CONTRACTOR: BOVIS LEND LEASE
DRAWING TITLE: GRAND STAIR #6 RAILING ; PARTIAL PLAN
AMERICAN ARCHITECTURAL INCORPORATED
DATE: 9-27-2001
DRAWN BY: S.AMERI
SCALE: 1/2"=1'-0"
PROJECT NUMBER: 00-220

DRAWING NUMBER: PL-1

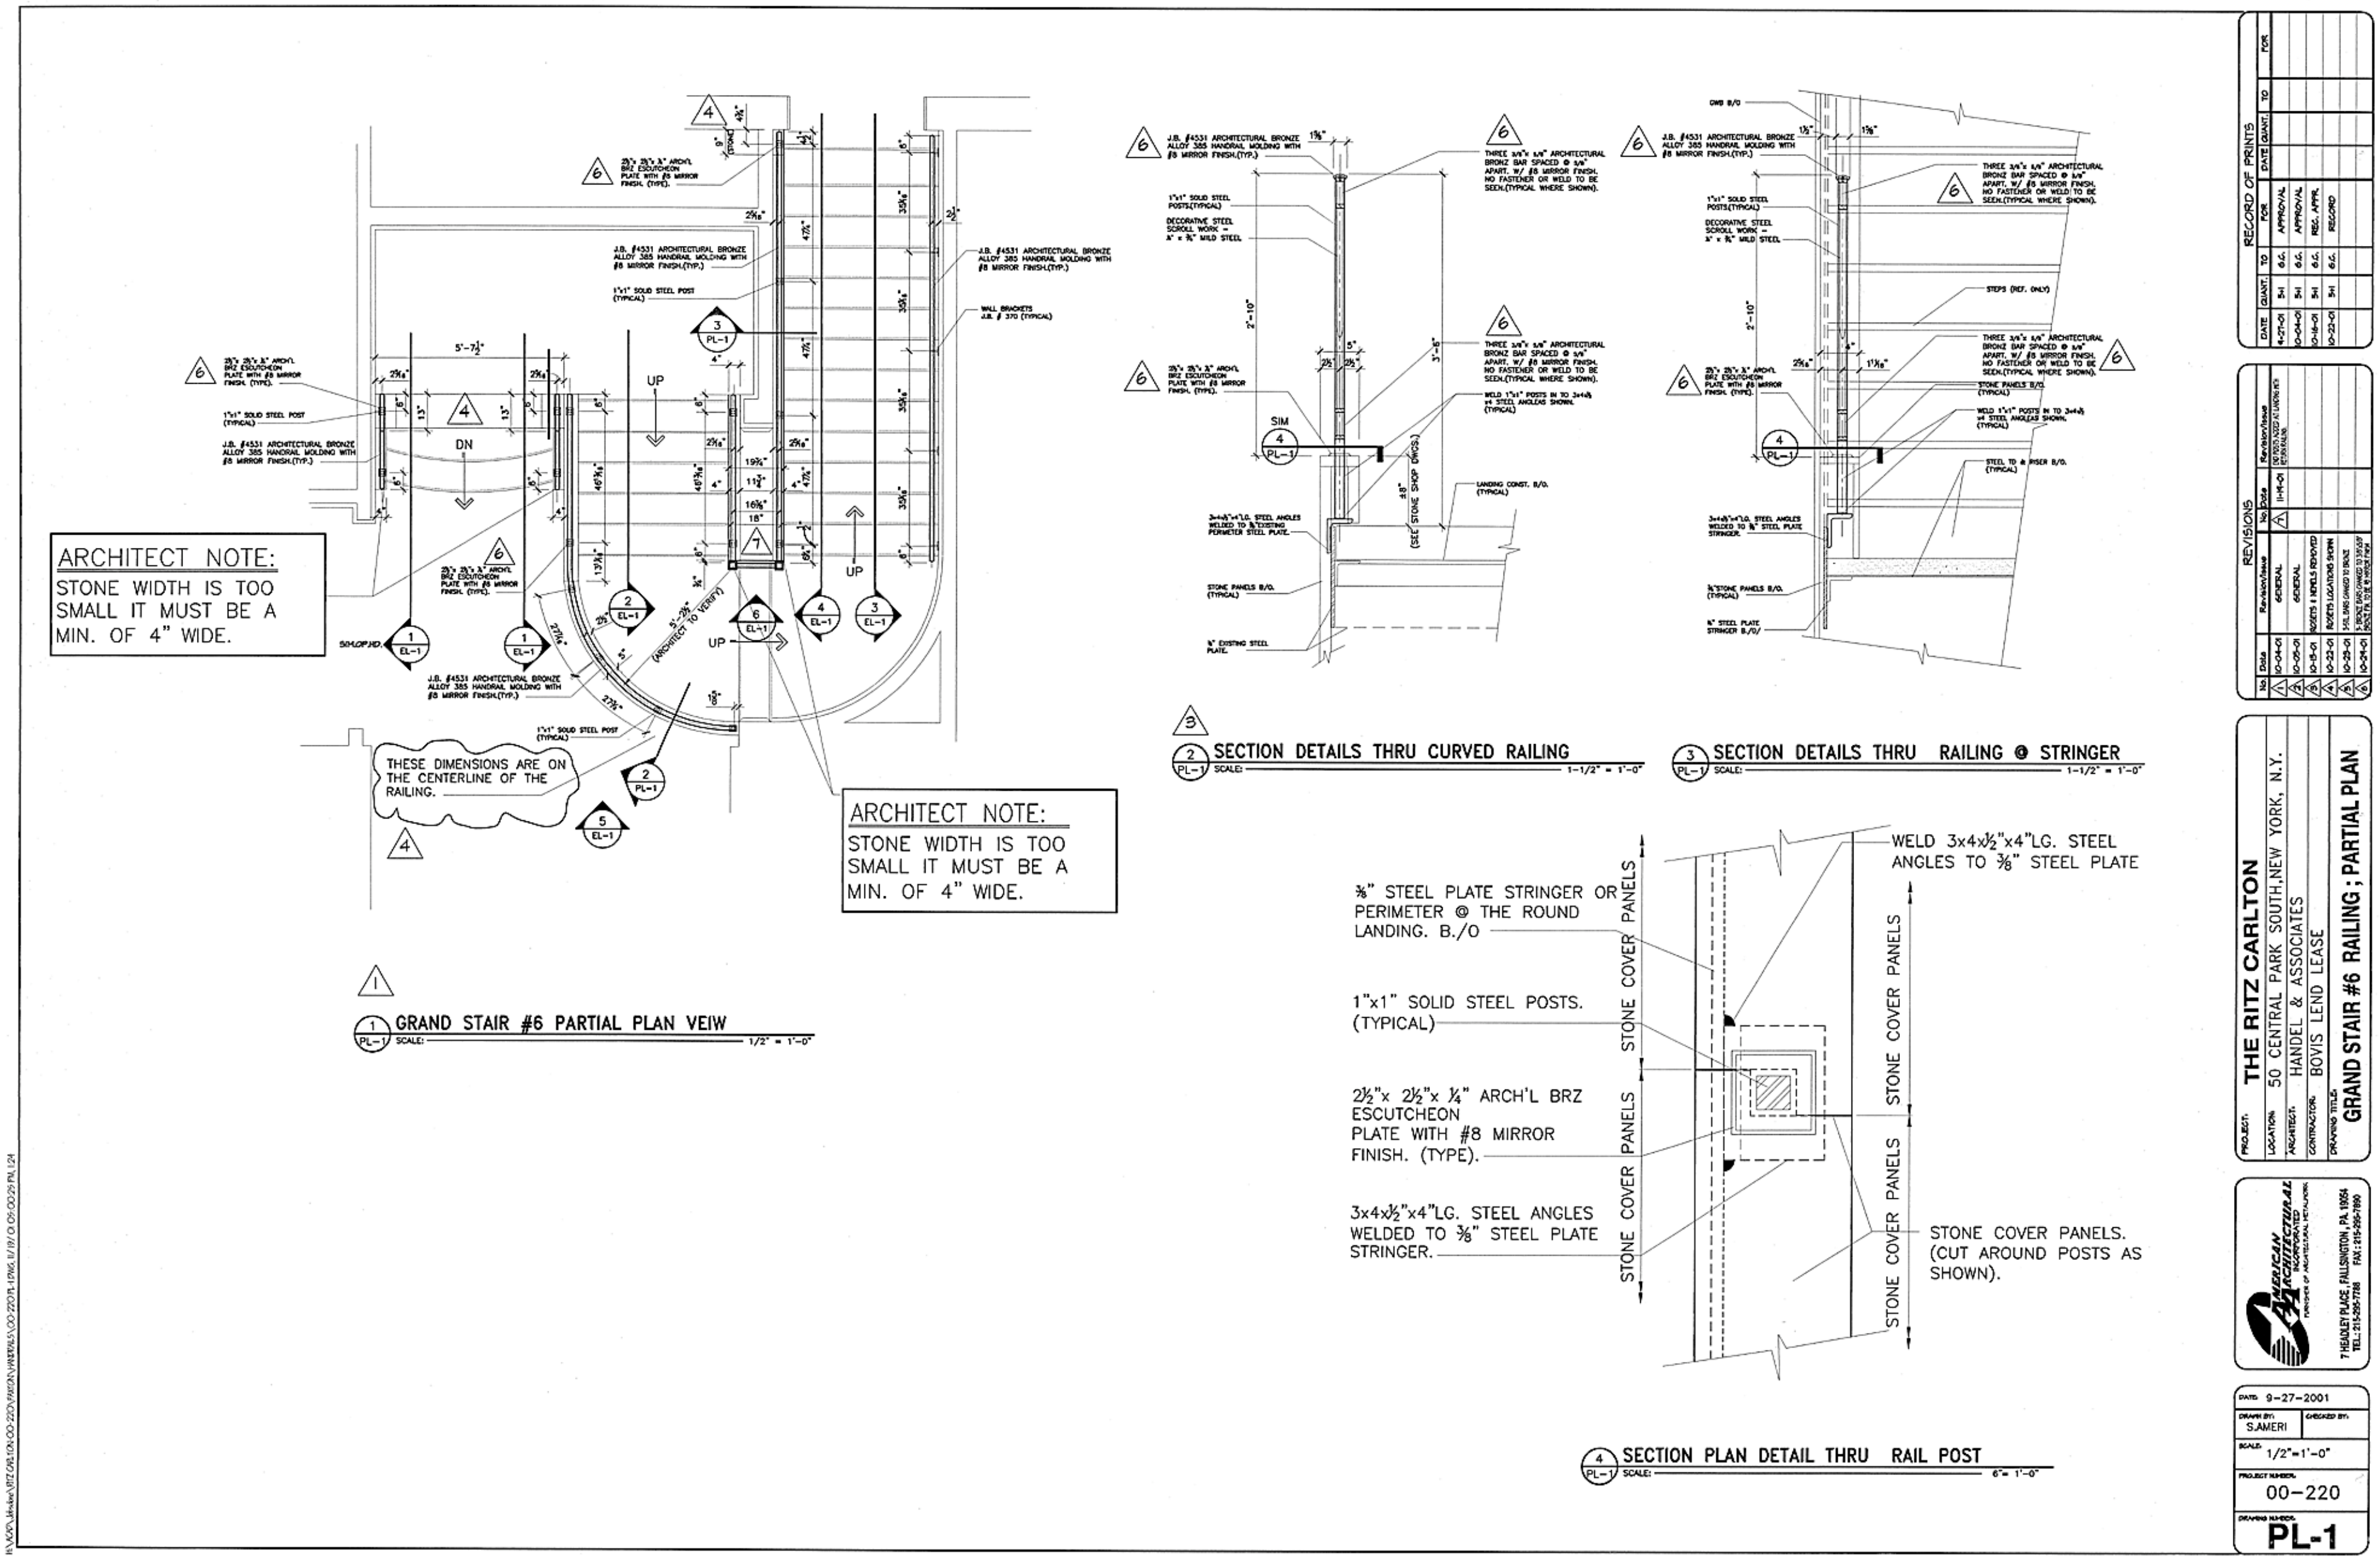
ARCHITECT NOTE:
STONE WIDTH IS TOO SMALL IT MUST BE A MIN. OF 4" WIDE.
THESE DIMENSIONS ARE ON THE CENTERLINE OF THE RAILING.
ARCHITECT NOTE:
STONE WIDTH IS TOO SMALL IT MUST BE A MIN. OF 4" WIDE.
1 PL-1 GRAND STAIR #6 PARTIAL PLAN VEIW
SCALE: 1/2" = 1'-0"
2 PL-1 SECTION DETAILS THRU CURVED RAILING
SCALE: 1-1/2" = 1'-0"
3 PL-1 SECTION DETAILS THRU RAILING @ STRINGER
SCALE: 1-1/2" = 1'-0"
WELD 3x4x½"x4"LG. STEEL ANGLES TO ⅜" STEEL PLATE
⅜" STEEL PLATE STRINGER OR PERIMETER @ THE ROUND LANDING. B./O
1"x1" SOLID STEEL POSTS. (TYPICAL)
2½"x 2½"x ¼" ARCH'L BRZ ESCUTCHEON PLATE WITH #8 MIRROR FINISH. (TYPE).
3x4x½"x4"LG. STEEL ANGLES WELDED TO ⅜" STEEL PLATE STRINGER.
STONE COVER PANELS
STONE COVER PANELS. (CUT AROUND POSTS AS SHOWN).
4 PL-1 SECTION PLAN DETAIL THRU RAIL POST
SCALE: 6" = 1'-0"
RECORD OF PRINTS
REVISIONS
PROJECT: THE RITZ CARLTON
LOCATION: 50 CENTRAL PARK SOUTH, NEW YORK, N.Y.
ARCHITECT: HANDEL & ASSOCIATES
